Project	IEEE 802.16 Broadband Wireless Access Working Group < http://ieee802.org/16 >	
Title	New SAPs in the Convergence sub-layer	
Date Submitted	2004-08-17	
Source(s)	Min-Sung Kim, Yongjoo Tcha, Seong-Choon Lee KT 17 Woomyeon-dong, Seocho-gu, Seoul, 137-792, Korea	Voice: +82-2-526-6109 Fax: +82-2-526-5200 mailto: cyberk@kt.co.kr
	Seung-Hun Oh, Young-Han Kim SoongSil University Sangdo-dong, Dongjak-Gu, Seoul, 156-743, Korea	Voice: +82-2-814-0151 mailto: hkim@dcn.ssu.ac.kr
Re:	IEEE 802.16e-04/367r1-Call for Contribution on IEEE Project 802.16g	
Abstract	To assist seamless fast L3 handover, new services between the MAC and higher layers are proposed.	
Purpose	Discuss and adopt as the services between the MAC and higher layers.	
Notice	This document has been prepared to assist IEEE 802.16. It is offered as a basis for discussion and is not binding on the contributing individual(s) or organization(s). The material in this document is subject to change in form and content after further study. The contributor(s) reserve(s) the right to add, amend or withdraw material contained herein.

New SAPs in the Convergence sub-layer

Min-Sung Kim, Yongjoo Tcha, Seong-Choon Lee
KT

Fig 1. Sets of Neighbor BSs

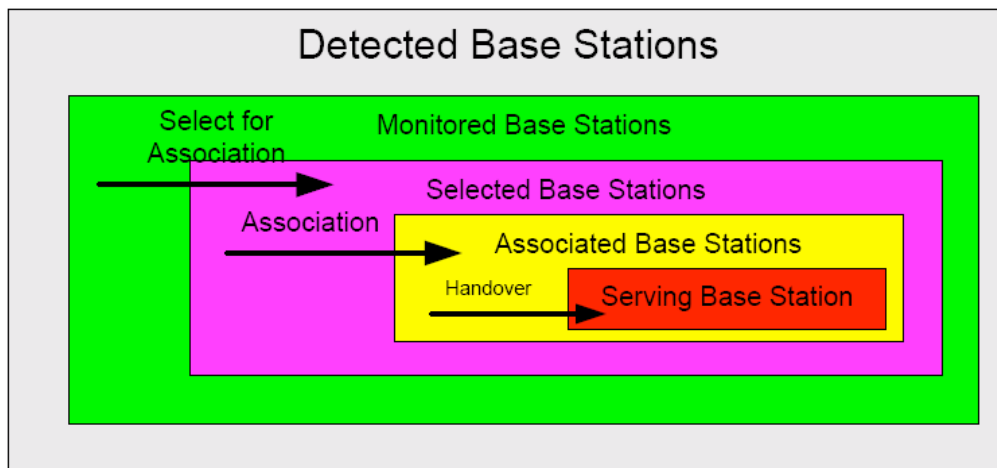
- _ nTriggering indication that MSS is about to hand-over to a new BS: This information (indication) is used to trigger FMIPv6 operation at the layer-3.
- _ nL-2 information of the detected neighboring BS: under FMIPv6, this information should be managed within MSS as a clue to identify/search the L-3 nodes corresponding to the target (candidate) BSs. Specifically, at least the ‘selected BSs’ among the set of the detected BSs in fig. 1 should be served for the higher application.
